## Product Change Notice

Smart Display PCB Solder Mask Change for Leopard, Cheetah and Saxon 4D 0.15

Below is the appearance comparison of HCMS-290x for reference:

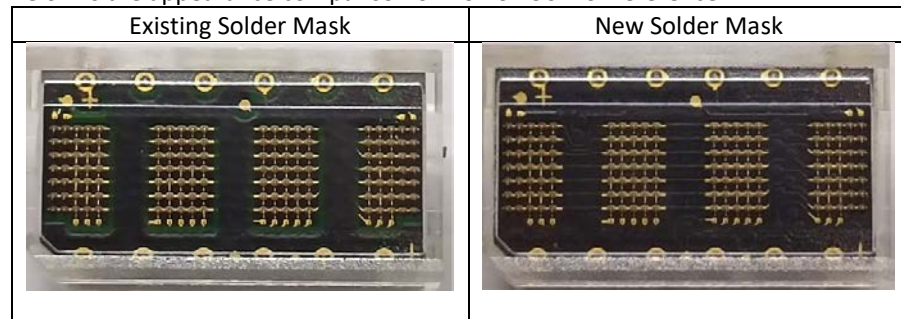
Solder mask optimization and material change. The new solder mask fully covers the PCB, providing a better cosmetic appearance.
